## **ABBREVIATED PLAT AGENDA**

STAFF REVIEW AND RECOMMENDATIONS  
PUBLIC HEARING  
AUGUST 9, 2023

ABBREVIATED PLAT: ROYAL FLUSH  
LEGAL DESCRIPTION: SEC 33, T18N, R02W, SEWARD MERIDIAN AK  
PETITIONERS: DANNY NOLAND II  
SURVEYOR/ENGINEER: LAVENDER SURVEY & MAPPING / WALDEN CONSTRUCTION  
ACRES: 10.00 ± PARCELS: 2  
REVIEWED BY: MATTHEW GODDARD CASE #: 2023-083

**REQUEST:** The request is to create two lots from Lots 1 & 2, MSB Waiver Resolution #81-117-PWm, Recorded as 81-205W, to be known as **ROYAL FLUSH**, containing 10.00 acres +/- . The property is located south and east of N. Meadow Lakes Loop, west of N. Pittman Road, and directly north of W. Sunrise Drive; within the NE ¼ Section 33, Township 18 North, Range 02 West, Seward Meridian, Alaska.

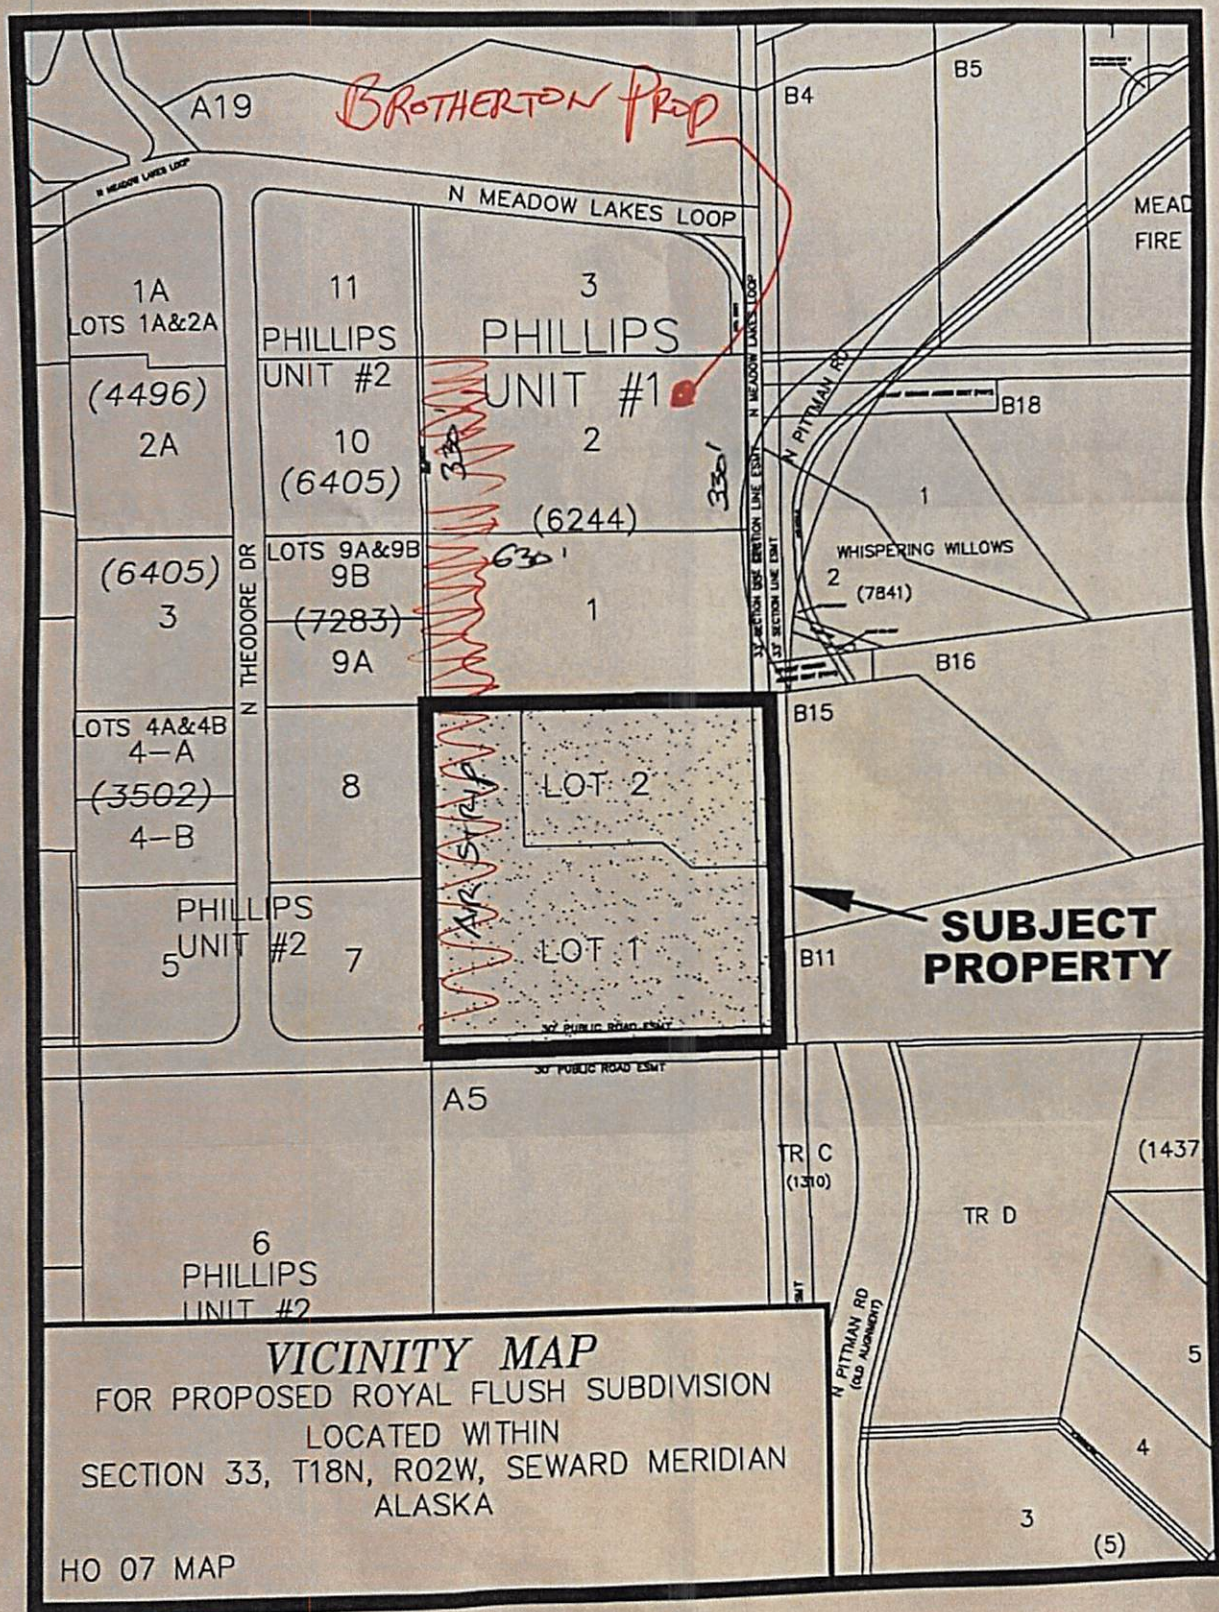
For the last 50 years the west 100 feet or so of the subject property, my property, and the in-between property (Phillip Unit #1, lot 1) has been used as a small plane private airstrip. There is no written agreement re the airstrip, only a mutual understanding between the parties that we do not encroach upon the airstrip.

Does the sub-division proposal recognize the existence of said air strip?

If not, then ***I request that the sub-division be denied*** until the matter is addressed ***and approved*** by both myself and my southern neighbors at Lot 1.

The current Platting Action does not recognize the air strip. The submitted Certificate to Plat (title report) does not show an easement covering the airstrip. If you have documentation showing a recorded easement for the airstrip noted, please email it to me and I will ensure it is noted. The usage of the land does not come into consideration during the platting process, as such the potential use of the air strip is a civil matter that would need to be resolved by the affected parties.

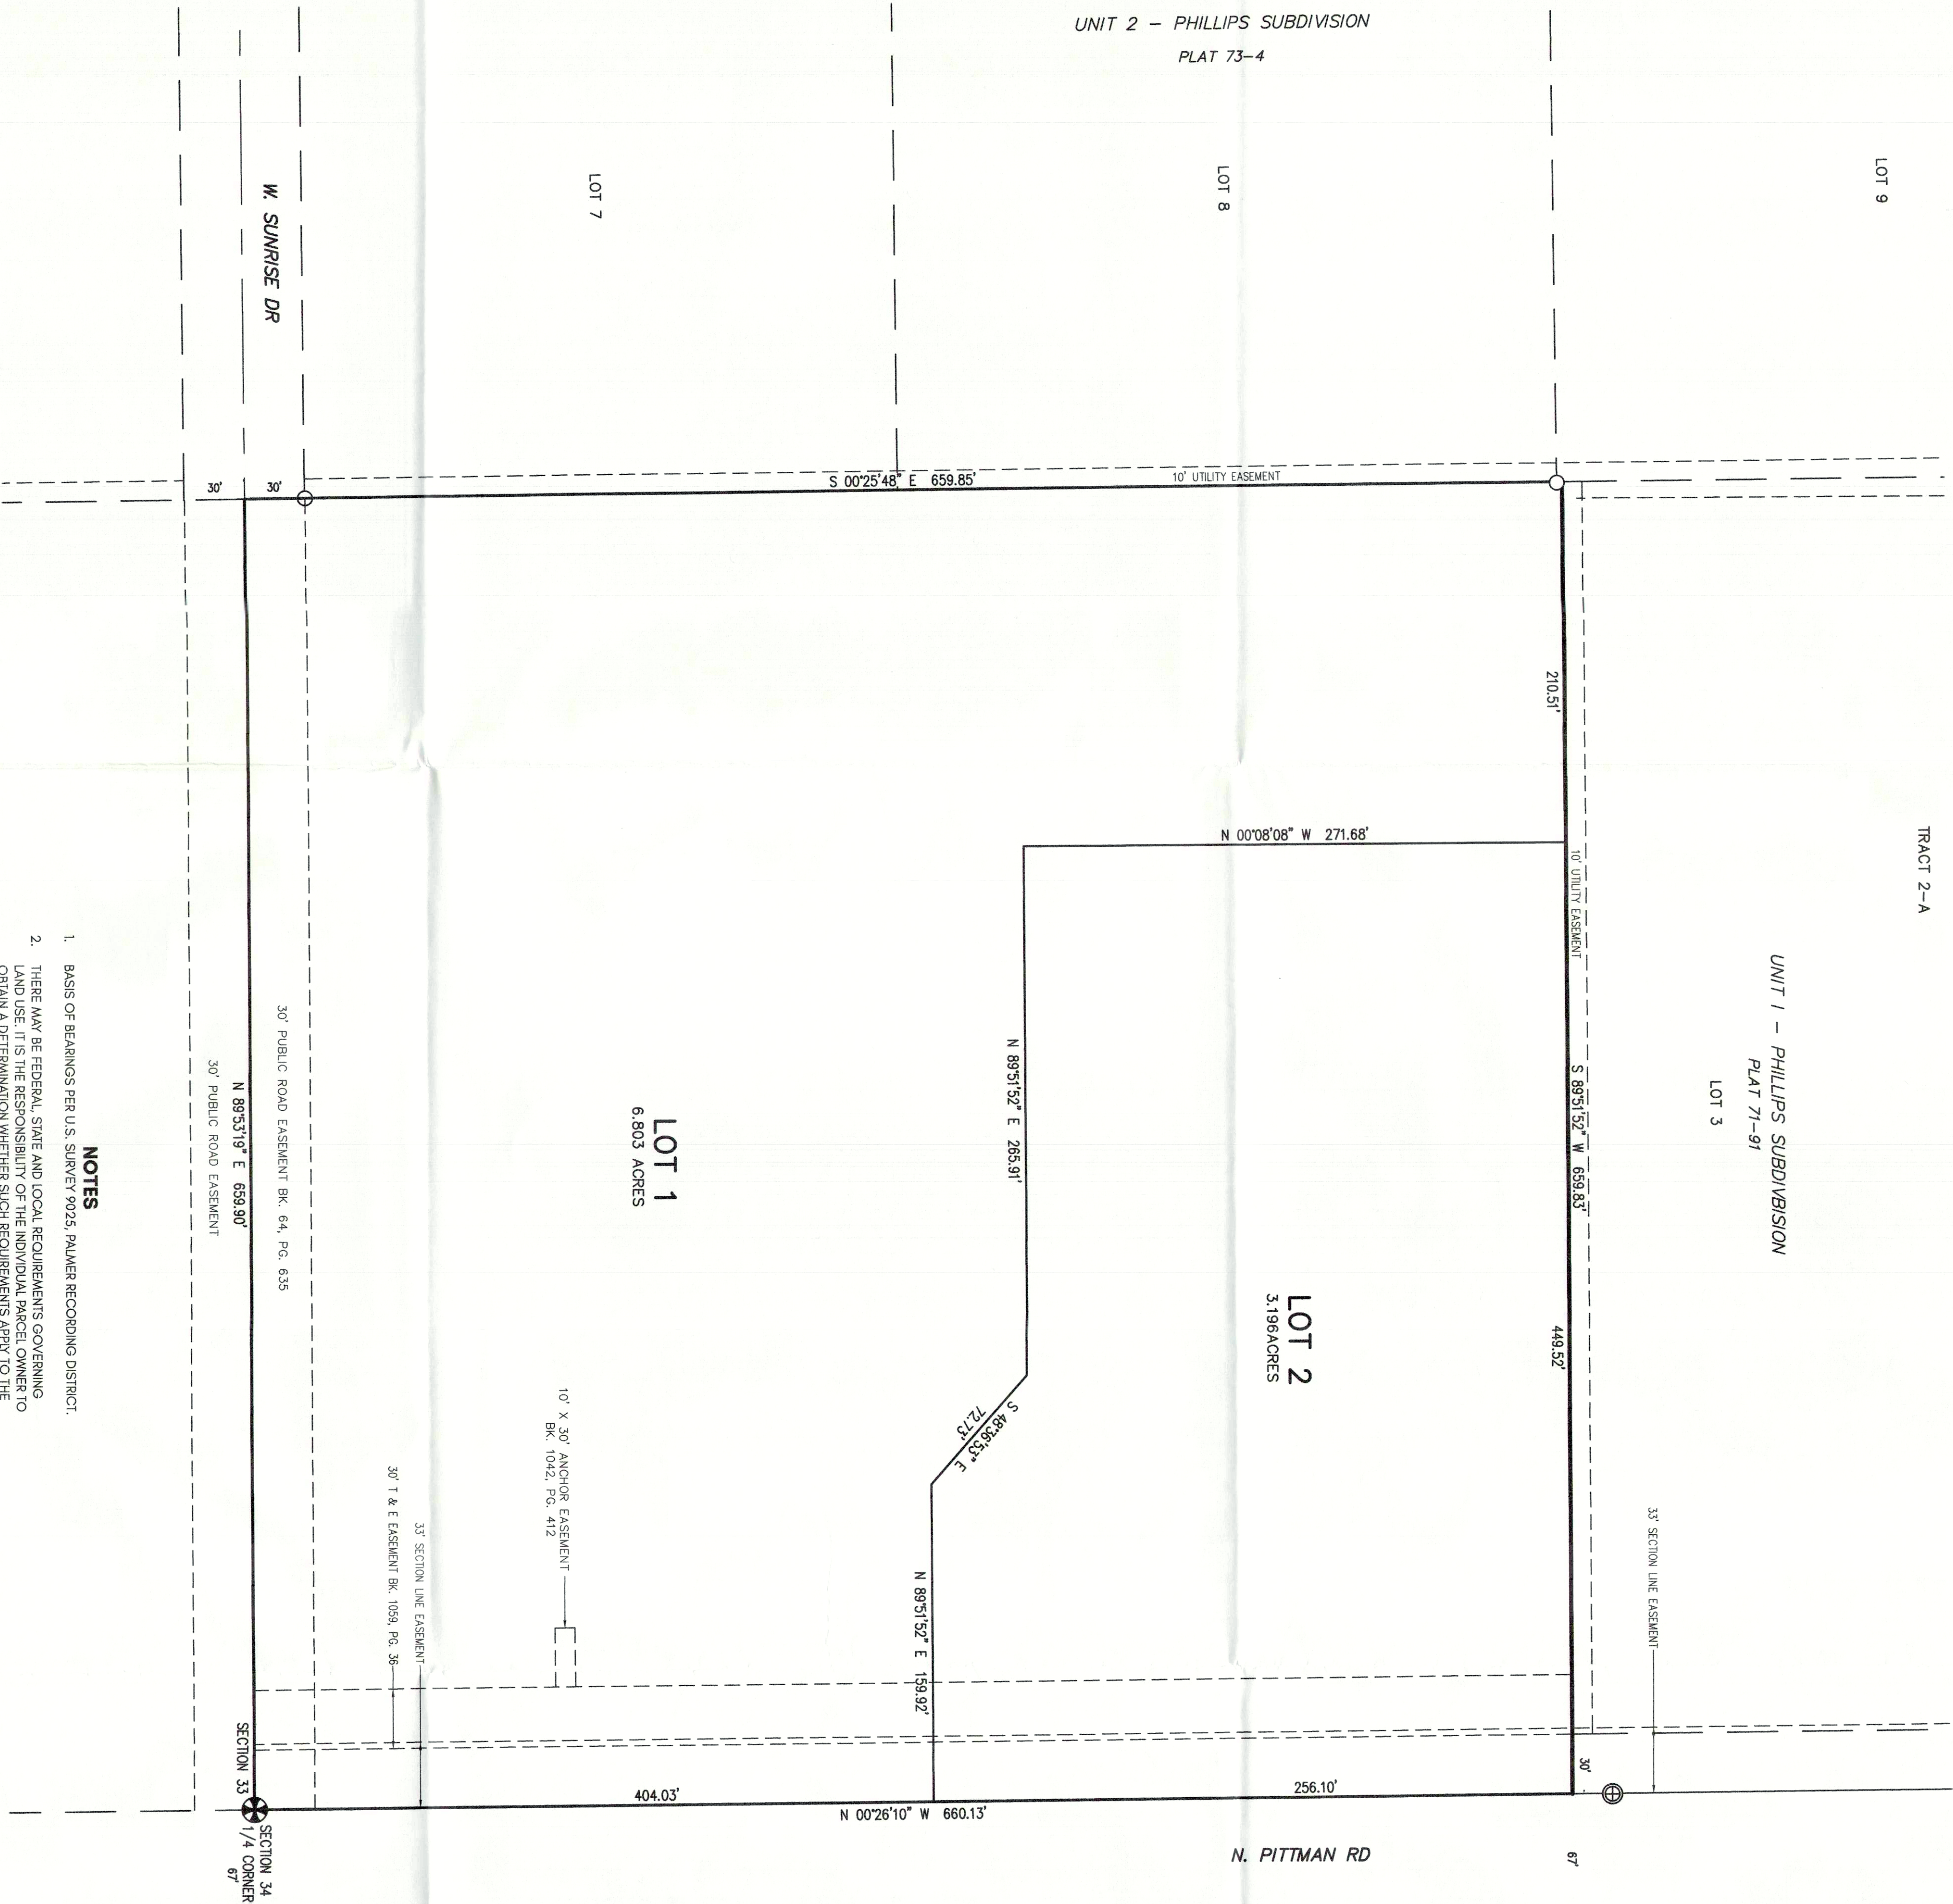
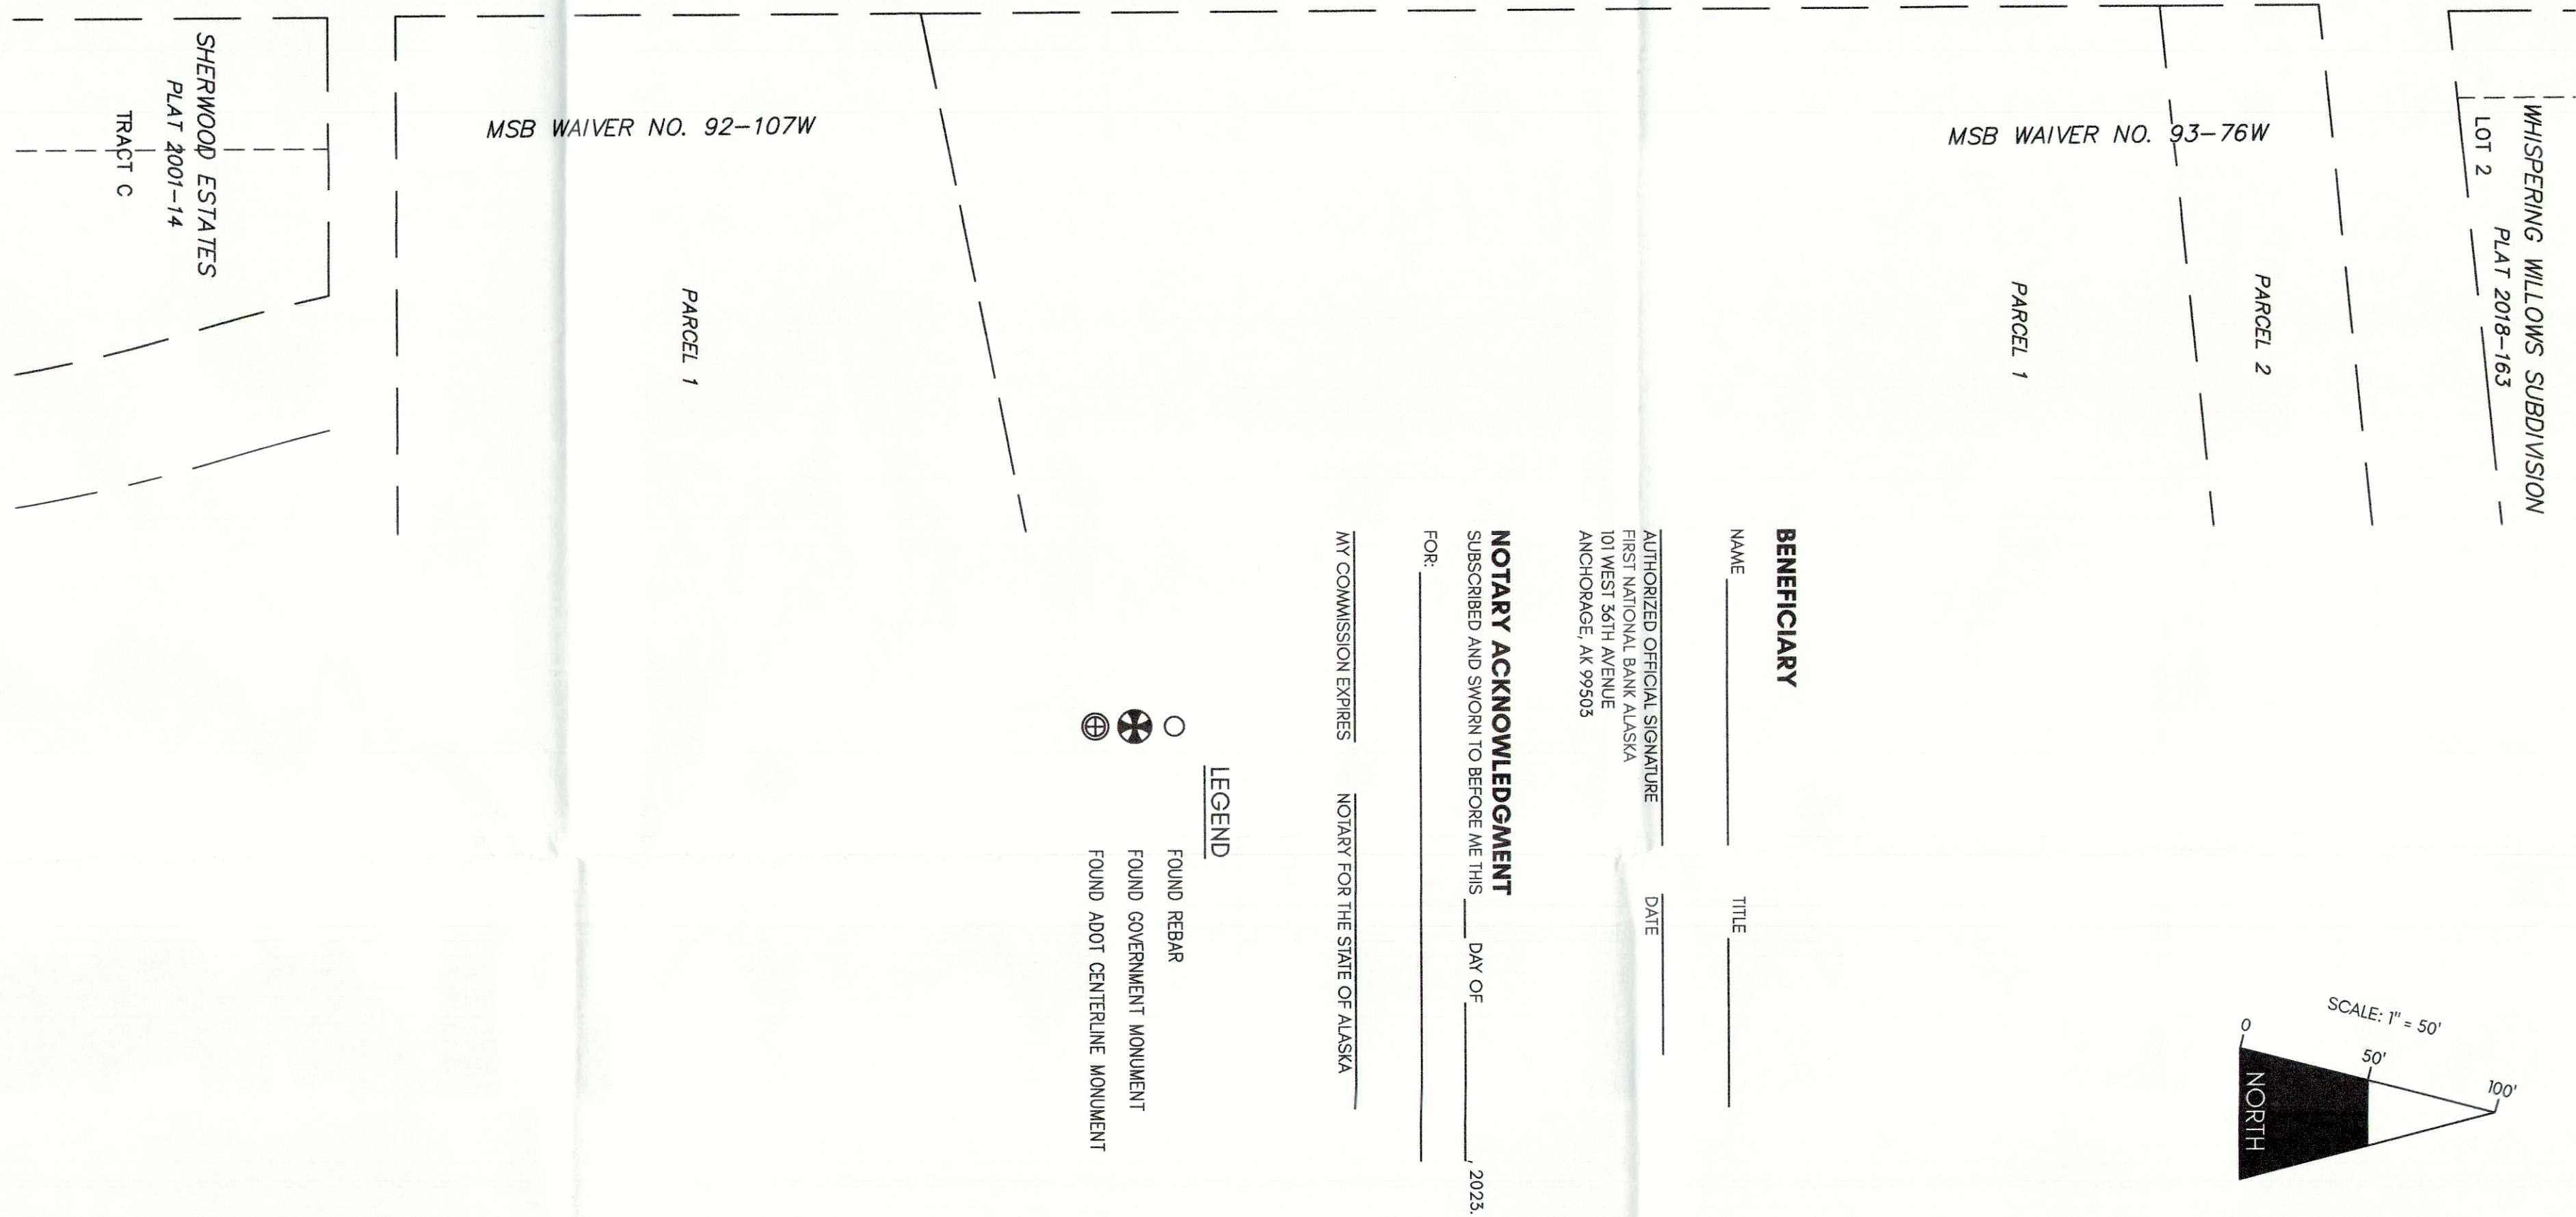
ADOT&PF (**Exhibit D**) has no objections to the proposed subdivision. DOT&PF notes that proposed Lot 1 will be required to take access from Sunrise Drive (**Recommendation # 3**). Lot 2 will be permitted one access to Pittman Road. The petitioner will need to re-apply for a driveway permit at this location (**Recommendation #4**). DOT&PF requests verification of the location of existing access to Lot 2 from Pittman Road. *Platting Staff notes that the driveway has since been relocated and the as-built shows the driveway as it exists today.* Future development of Lot 2 is not guaranteed driveway access through Pittman Road.

MSB Department of Public Works (**Exhibit E**) Notes that the petitioner should continue to coordinate with AK Department of Transportation for access onto Pittman Road. It appears the as-built is missing a structure located near the lot line between Lot 1 and Lot 2. Petitioner will need to verify proposed lot lines meet MSB code setback requirements (**Recommendation #5**).

MSB Planning (**Exhibit G**) recommends that both proposed lots maintain legal access to Sunrise Drive as it is the lower classification roadway. *Platting Staff notes that access for proposed Lot 2 onto N. Pittman Road has been approved by ADOT&PF.*

MSB Assessments (**Exhibit H**) notes the waiver number on the Agenda Plat is incorrect. The waiver should read 81-205W. *Platting staff notes that this will be corrected before recordation.*

- No objection to the proposed lot division.
- DOT&PF requires that Lot 1 take driveway access through Sunrise Dr.
- Lot 2 will be permitted one access to Pittman Road. DOT&PF requires petitioner re-apply for driveway permit at this location. DOT&PF requests verification of the location of existing access to Lot 2 from Pittman Road as historical imagery brings ownership of its location into question.

- Future subsequent development of Lot 2 not guaranteed driveway access through Pittman Road. As road connectivity and network improvements continue along Pittman Road, the existing Pittman Road access is in a high conflict zone due to proximity with Meadow Lakes Loop road, the curvature of the Pittman Road alignment at this location, and the proposed western alignment of Seldon Extension through Zehnder Road area. Because of this, applicant should consider a shared access for Lot 2 with Lot 1 to Sunrise Dr.

- DOT&PF requests 50 foot right of way dedication along Pittman Road.

Petitioner should continue to coordinate with AKDOT for access onto Pittman Road. PD&E would prefer subdivision to be designed so that both lots have access onto Sunrise Drive. It appears the as-built is missing a structure located near the lot line between Lot 2 and Lot 1. Please show this structure on the built and verify proposed lot lines meet MSB code setback requirements.

The Planning Division recommends that both proposed lots maintain legal access to Sunrise Drive as the lower classification roadway.

1) I see on the Agenda Plat and As-built that is linked that they have listed plat 81-20W, it should be 81-205W.  
Thanks!

3. Add a Plat Note stating that no access to N. Pittman Road shall be granted to Lot 1 unless otherwise approved by the permitting authority.
4. Apply for a driveway permit for the N. Pittman Road access with the State of Alaska Department of Transportation & Public Facilities. Provide a copy of the application to Platting Staff.

5. Submit an updated as-built showing all structures to include distance from lot lines.
6. Pay postage and advertising fees.
7. Show all easements of record on final plat.
